**Appln No. 10/041,888**

**Reply to Office action of April 6, 2005**

**REMARKS/ARGUMENTS**

Fig. 1

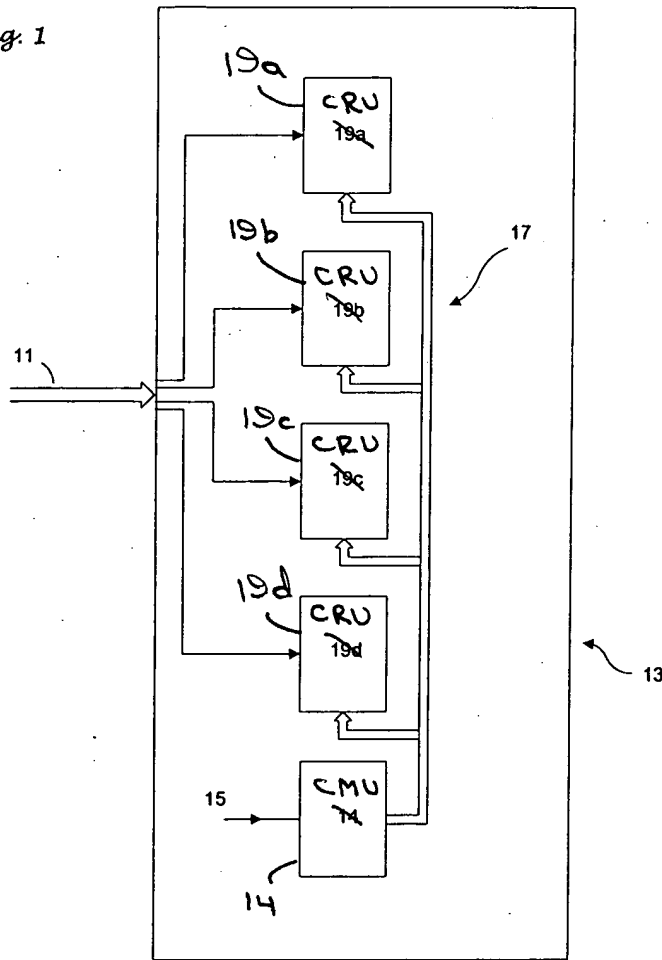
Turning now to the objections to the drawings, Figures 1-5 are objected to as not including text label in the various boxes. In addition, Figure 2 is objected to as not showing a clock distribution network 27, as indicated in the specification in page 4, lines 27-29.

Figure 1 is now amended to label the boxes identified by reference numerals 19a-d with the label "CRU". As indicated in the specification on p. 4, lines 8-10 "The clock distribution network couples the CMU to a plurality of clock recovery units (CRUs) 19a-d that are on the same chip as the CMU." Figure 1 is also amended to label the box identified by reference numeral 14 as "CMU". As indicated in the specification "A clock master unit (CMU) 14 located on the chip receives a reference clock signal 15..." Specification, p. 3, lines 34-35.
